61 MILBURN CIRCLE, PASADENA, MD 21122 | ADMINISTRATIVE SITE PLAN

CONFIRMATION OF PRE-FILE (2025-0014-P)

SITE LOCATION: 61 Milburn Circle, Pasadena LOT SIZE: 37,978 sf ZONING: R2

CA DESIGNATION: LDA/RCA BMA: N/A or BUFFER: Yes APPLICATION TYPE: Critical Area Variance

EXISTING SITE CONDITIONS AND RESOURCE MAP

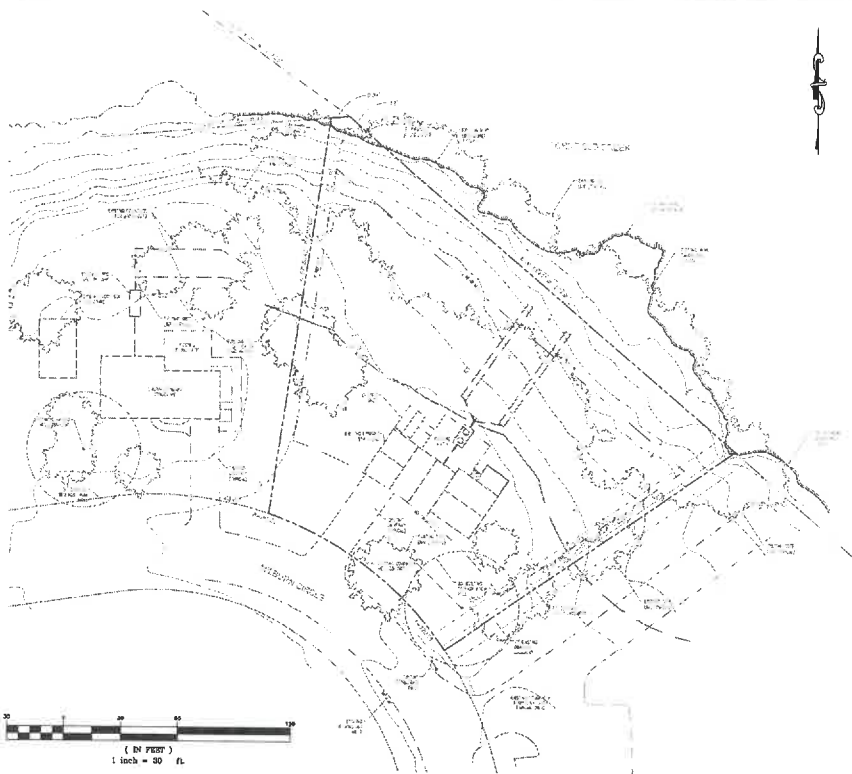
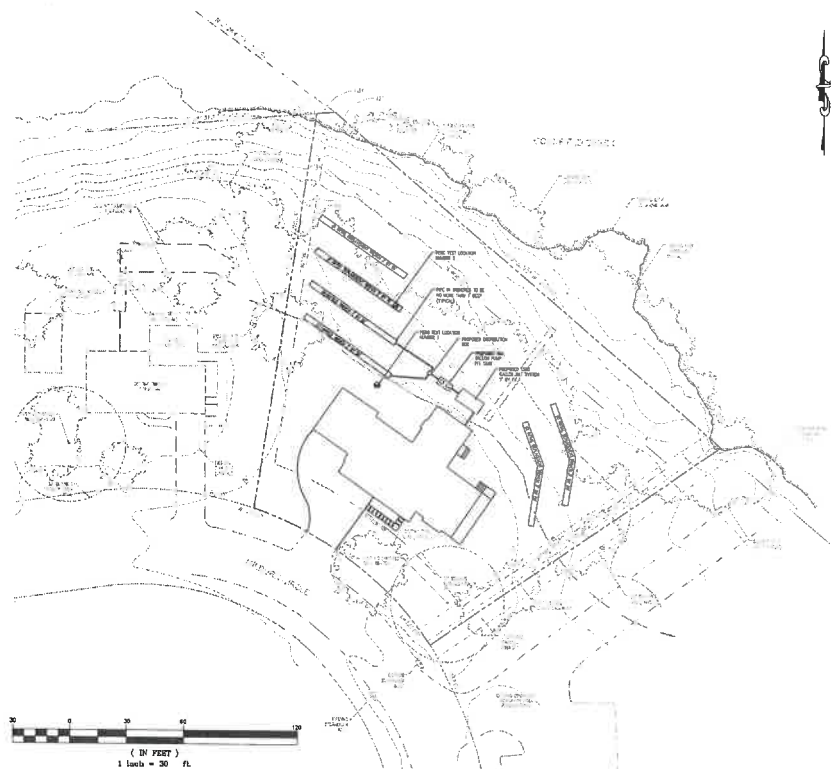
The proposed addition abuts the buffer/expanded buffer. Inspections and Permits will require a 10' LOD around the addition which will fall within the buffer, is considered disturbance, and will require a variance. Since the addition could be designed to avoid disturbance to the buffer, it will be difficult for the applicant to meet the approval standards outlined in the Code. The Team recommends that the [dwelling] be redesigned to allow for the LOD to be located outside of the buffer, thereby eliminating the need for the variance.

The **Zoning Administration Section** notes that all variance site plans must label the dimensions, number of stories, and height for the proposed structure(s). The Zoning Administration Section concurs with the Critical Area Team that the dwelling could easily be redesigned in order to keep the structure and the associated LOD outside of the buffer, eliminating the need for a Critical Area variance. Should the applicant decide to pursue a variance, the applicant must

1. Show the existing septic system on the Existing Site Conditions and Resource Map.
2. The SWM devices need to be defined. Show the approximate limits of the SWM devices.

3. SWM devices must have a setback of at least 10 feet from structures. Relocate SWM-3 and SWM-4.
4. SWM-4 must be a minimum of 25 feet from the well unless the Health Department requires an even greater setback.

5. SWM-1 and SWM-2 must be a minimum of 10 feet from the property lines.
6. SWM-1, SWM-3, and SWM-4 must be 25 feet from the septic drainfield trenches, replacement trenches, and the septic area.

7. The invert of the SWM devices requires 4 feet of separation from ground water.
8. Label the specific type of SWM devices on the plan.
9. Show the limits of disturbance on the plan.

10. Label the North arrows.
11. Will the living shoreline construction be accessed from the water or the land?
12. Clarify why the Total Disturbed Area and the Proposed Lot Coverage is 0 sf under Site Information.
